Subject: Test of Trajectory Generator on TMA

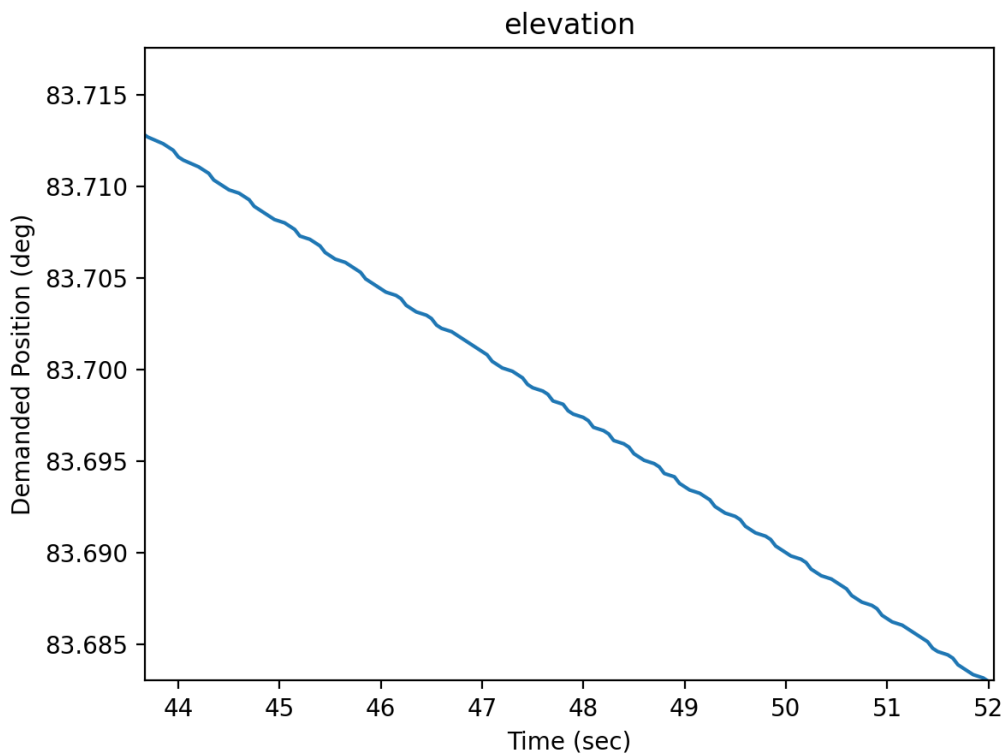
Demanded position looks great but there are the spikes in the demanded velocity (I only show the el data but az is the same):

You can see the time=96sec and time=254sec at demanded velocity. If we check the demanded position at smaller range as the following:

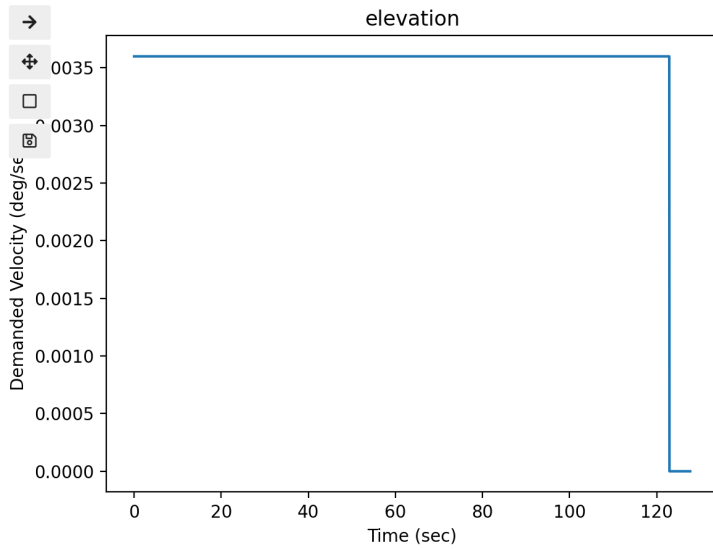
You could see some oscillation there. However, the related demanded velocity does not have this and keeps constant -0.0036 deg/sec. I am kind of confused with this.

2. Tracking speed is 0.0036 deg/sec at az, el directions (timestamp: 1669851805.426)

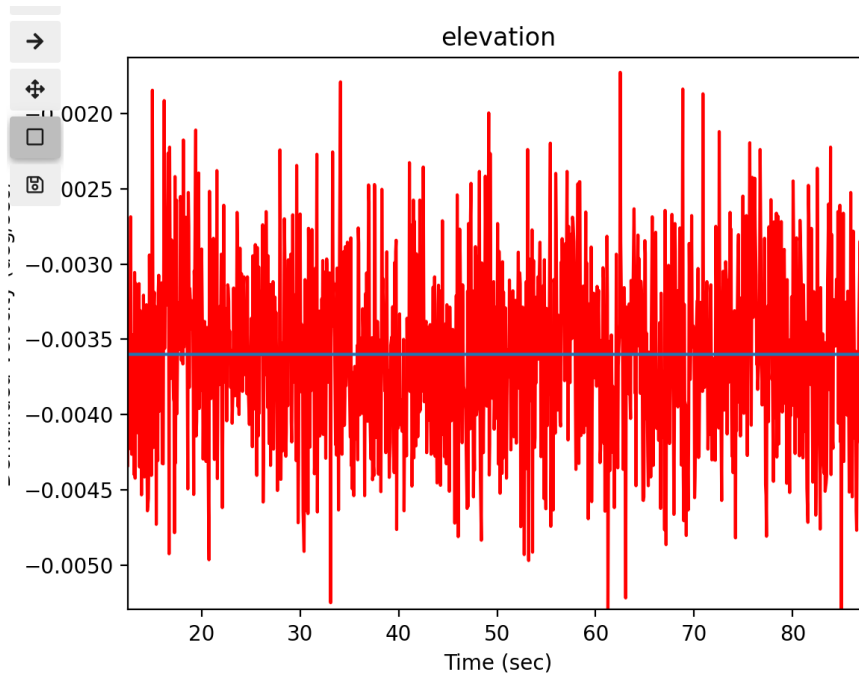
You could see there is no spike in demanded velocity here.
